SCAUWG CHART MASTER Candace Robinson

SCAUWG REPORT MAY 09, 2023

LOS ANGELES TERMINAL AREA CHART -- CHANGES

NAVIGATION SIDE OF CHART

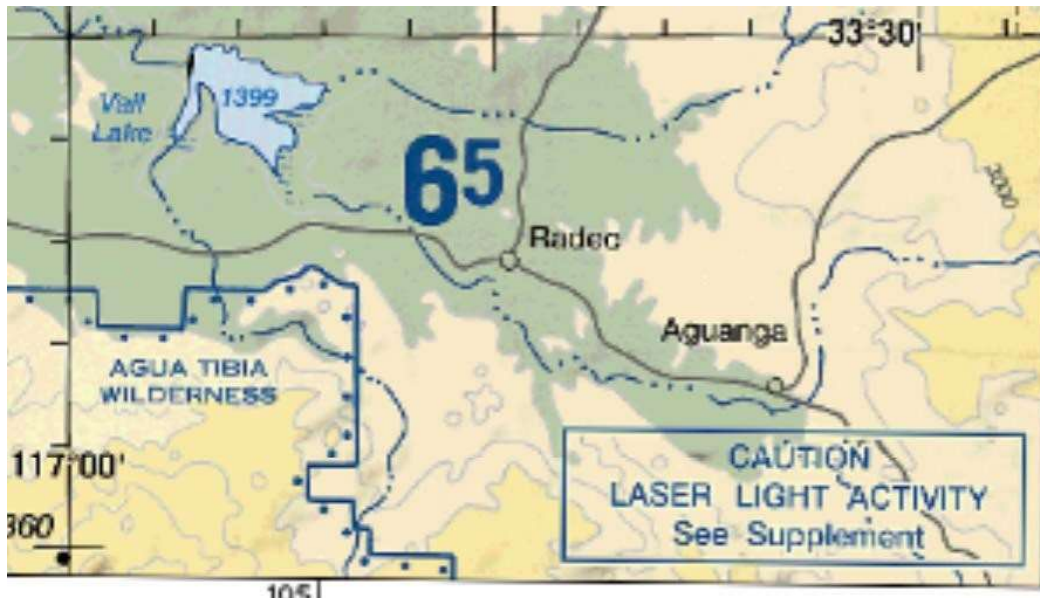
The obstruction symbol (above 299' AGL) west of San Antonio College VFR Checkpoint has grown from 1394 feet msl to 1410 feet msl.

In the southeastern corner of the TAC chart, there is a note “CAUTION LASER LIGHT ACTIVITY, See Supplement.”

In the current Chart Supplement Southwest, there are six Laser Light Demonstrations. It is not clear which one applies to the charted note. There should be more information in the Chart Supplement to identify which notice applies.

Should it be recommended that the name used in the Chart Supplement be included on the LA TAC chart?

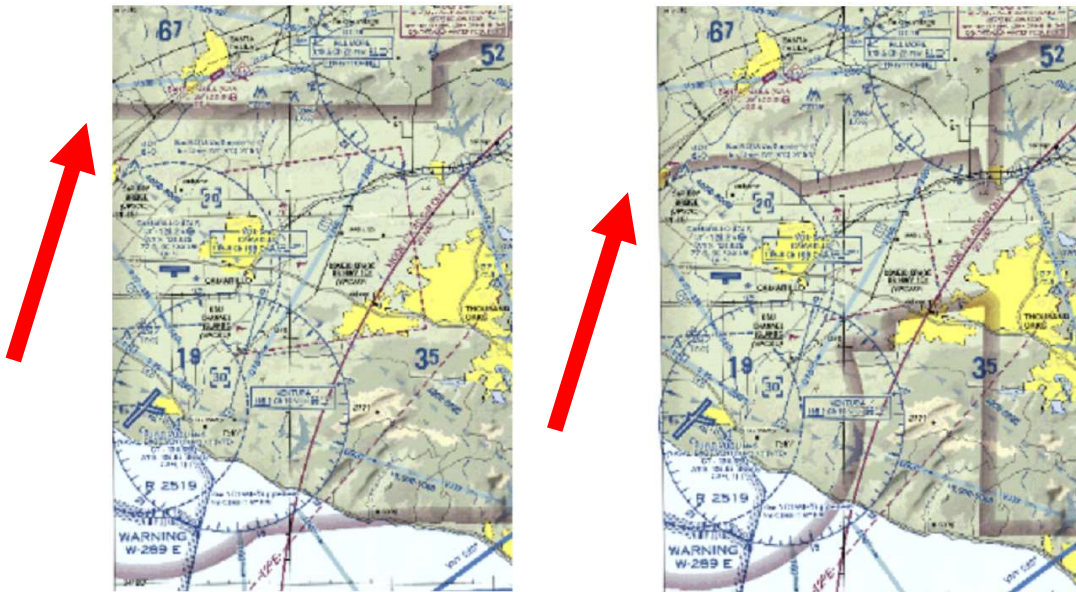
Between Camarillo Airport and Thousand Oaks, a lot of Class E airspace with a floor 700 ft. above the surface has been freed up.

Point Magu NAS Class D airspace has been moved eastward about .2 nm.

Camarillo Class E extension has been shortened to the west by about 2 nm.

Camarillo Class E extension has been narrowed from 7.5 nautical nm to less than 5 nm.

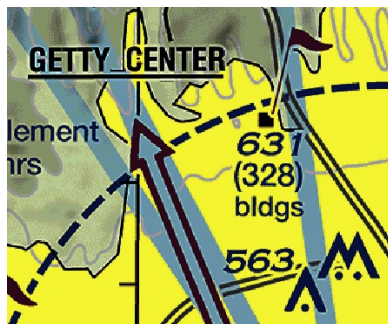
GROUP OBSTRUCTIONS: The Group Obstructions around Getty Center show that the building obstruction previously charted at 631 MSL/328 AGL has grown to 667 MSL/379 AGL. I'm still trying to figure out how the msl altitude increased by only 36 feet while the AGL altitude increased by 51 feet.

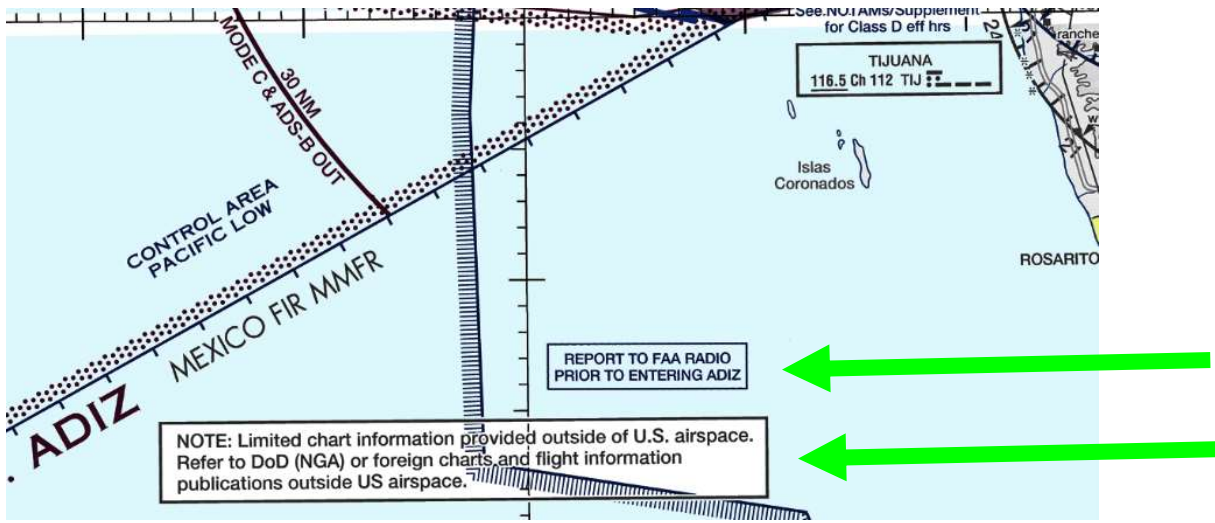
One example can be found southeast of San Clemente Island, south of the US/Mexico border. Red arrows are for deletions, green arrows show the additions. Additionally, Mexico will now be published in black and white.

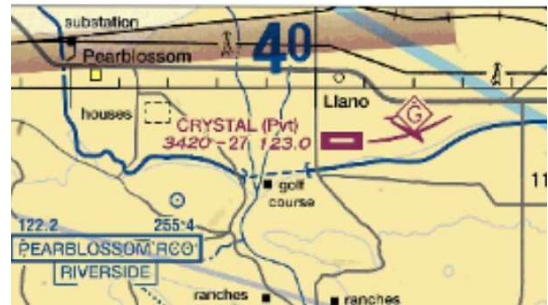
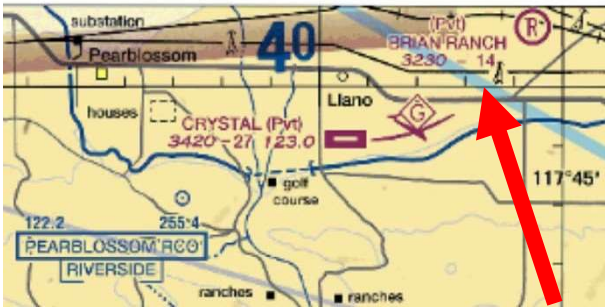
East of Santa Barbara Island, located in the southwest corner of the chart shows a website for referencing National Marine Sanctuaries. The underlining of the website has been removed on the current edition of the TAC chart. Checking the Aeronautical Chart User's Guide, no specification for a charting convention for website addresses can be found; however, none of the other five websites cited on the TAC chart are underlined.

The underlining was also removed on Flyways side of the chart.

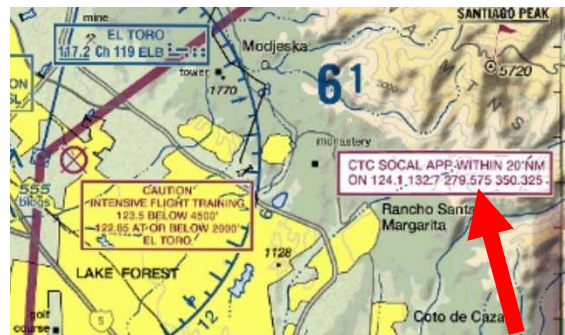
East of El Toro VOR, the box containing the information for Social Approach was updated to add frequencies 132.7 and 279.575. This information box is not charted on the Flyways side of the chart.

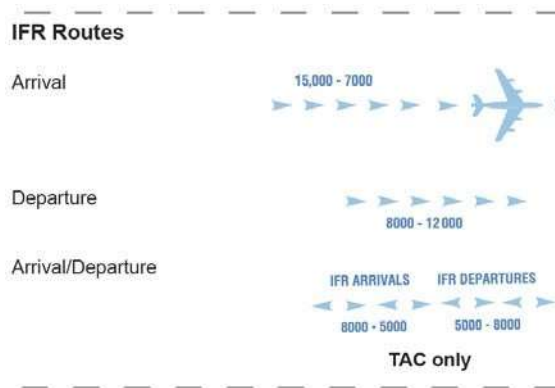
1. The IFR Departure Route symbol west of Ontario International (ONT) has been realigned to be straight out from Runway 26R.

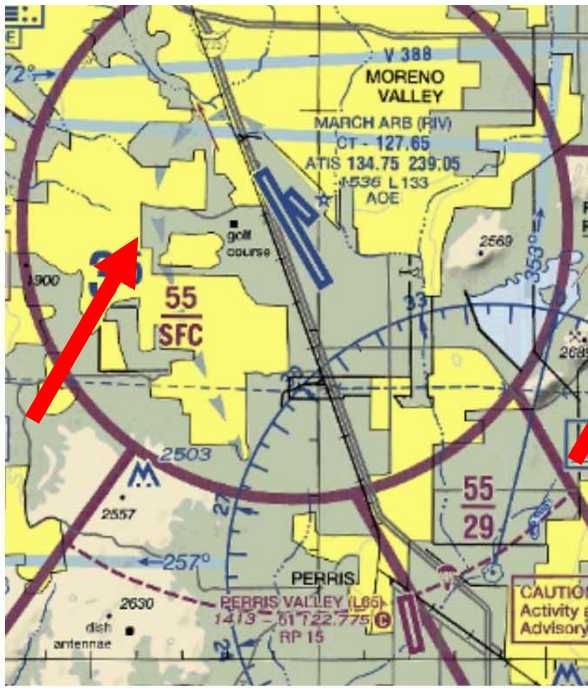
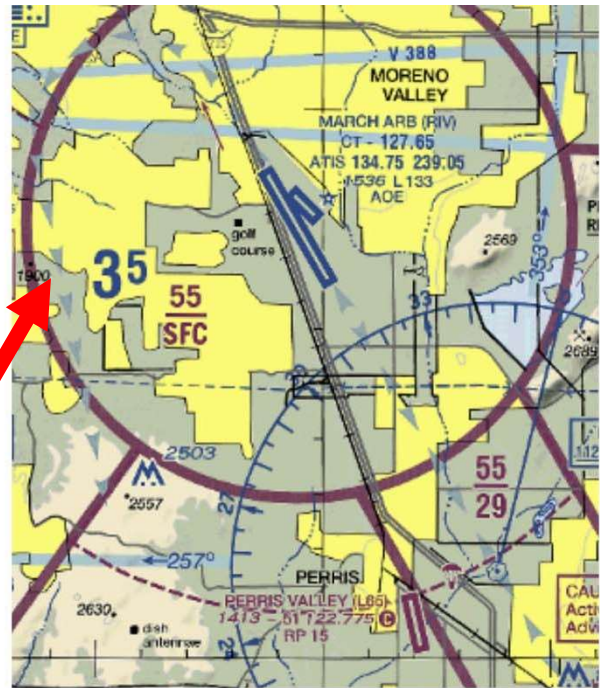
2. West of San Bernardino (SBD) a symbol for the IFR Arrival/Departure Route has been added for Rwy 6/24. A new IFR

Departure Route symbol shows a turn to the southwest after passing the 1280 ft (310 agl) obstructions towards Flabob (RIR).

3. The symbol for the IFR Departure Route off Rwy 6 has been modified from a southeast route to a departure that turns to the southwest.
4. West of SBD, Petis NDB has been recharted slightly to the south.
5. The depiction of runway at Redlands has been rotated tiny amount to the north. It is more noticeable on the flyways side of the TAC.
6. Several housekeeping changes have been made around SBD to accommodate the route changes.

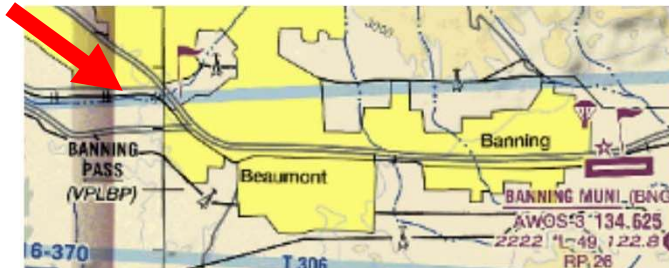
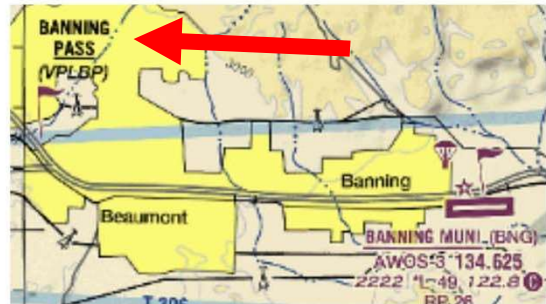
7. West of March AFB (RIV) the symbol for IFR Departure Route off of Rwy 32 has been modified from a tight left turn to more of a straight out departure, possibly to gain altitude over the populated area, before turning to a southeasterly route.
8. Southeast of RIV a symbol has been added for an IFR Arrival/Departure Route, beginning at the departure end of Rwy 14, extending southeast over the Homeland VOR, terminating southwest of Diamond Valley Lake.

TAC RECOMMENDATION

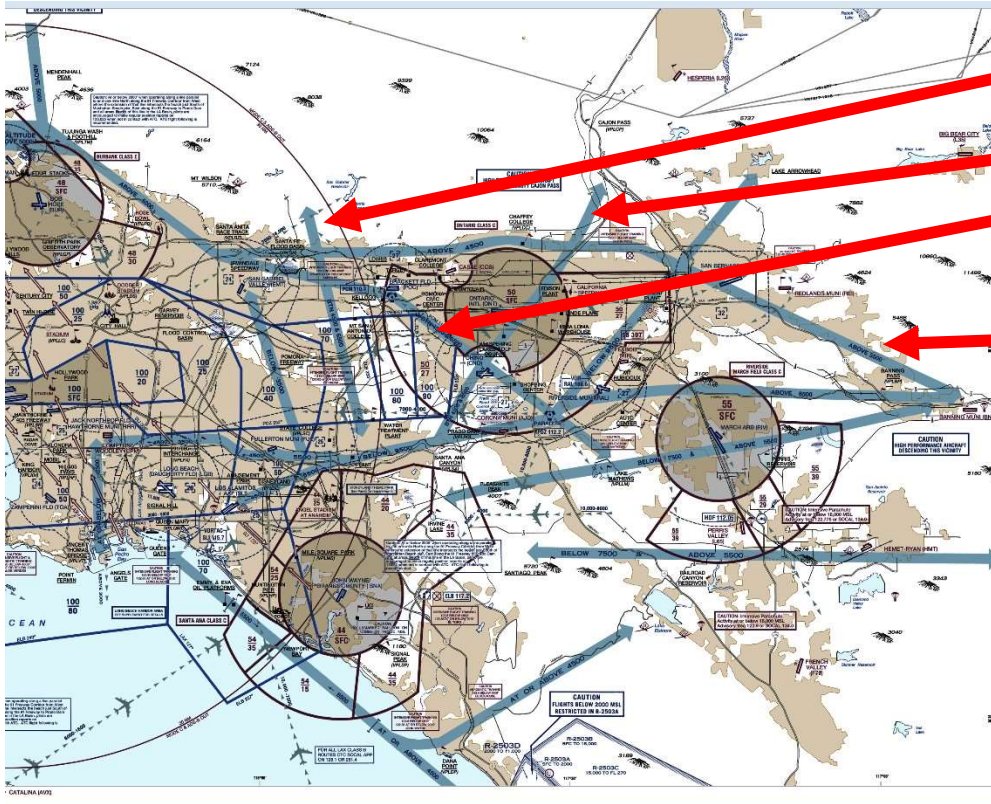
Several revisions ago (approximately 6/2020), the practice area note for Long Beach obscured the breakwater.

It should be updated to match the charting on the Flyways side of the chart.

REVIEW OF CHANGES TO THE FLYWAYS SIDE OF THE TAC

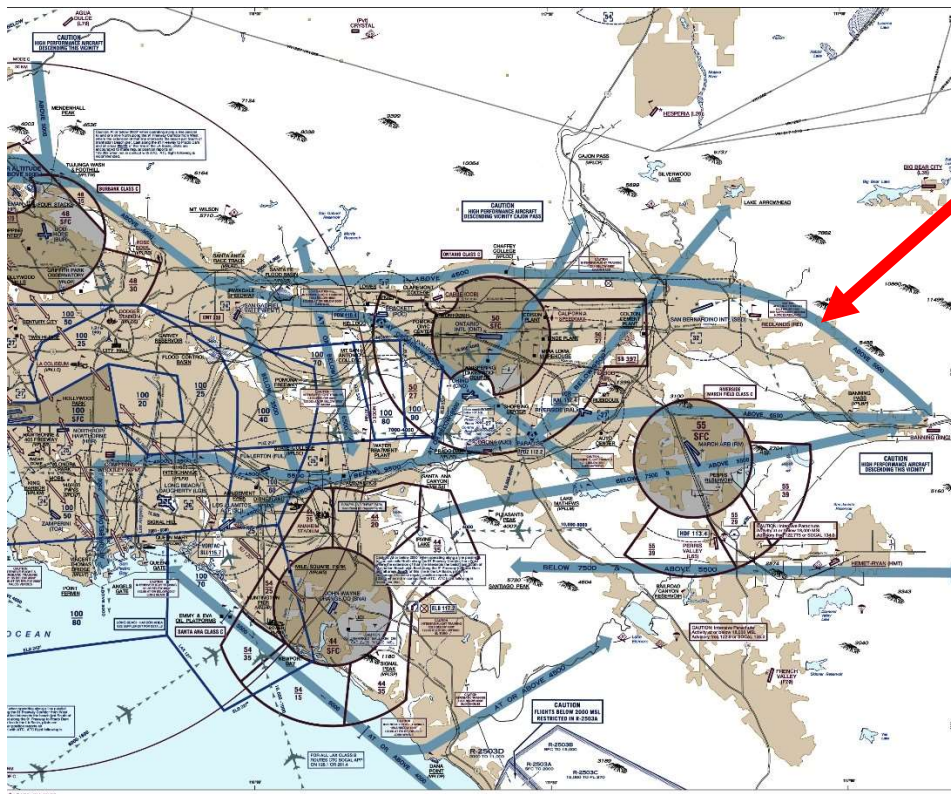
A Flyway rerouted to avoid Redlands Aerobatic Area

B Previously charted as “AT OR BELOW 6500.” Changed to “BTN 4500 & 6500” to avoid the La Habra and Santa Fe flight training areas.

C Previously charted as “AT OR BELOW 8500.” Changed to “BTN 4500 & 8500” to avoid Ontario (ONT) Class C airspace. **NOTE: Should be changed to “BTN 5500 & 8500” to more completely avoid ONT Class C.**

D Southeast of Brackett (POC). Previously was “AT OR BELOW 8500”, changed to “BTN 4500 & 8500” to avoid departures to the west from ONT and ONT Class C. **NOTE: Should be changed to “BTN 5500 & 8500” to more completely avoid ONT Class C.**

CHANGE REQUESTED FOR CHART SUPPLEMENT SW

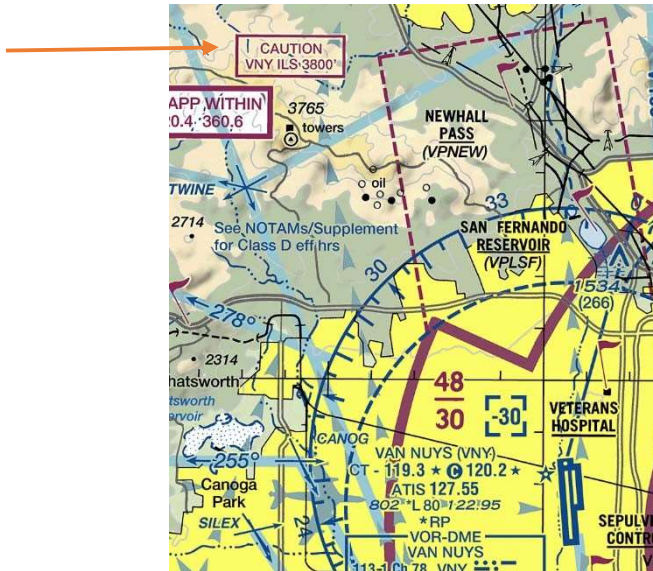
Long Beach Flying Club has received noise violations at LGB for VFR missed approaches outside the times permitted in the Airport Noise Compatibility Ordinance. It was pointed out to me that the listing for LGB in the Chart Supplement SW currently states:

Touch and go, stop and go, **practice** low apch, **VFR practice missed apch** only permitted 1500–0300Z \ddagger weekdays and 1600–2300Z \ddagger weekends and hol only on Rwy 08L–26R and Rwy 08R–26L.
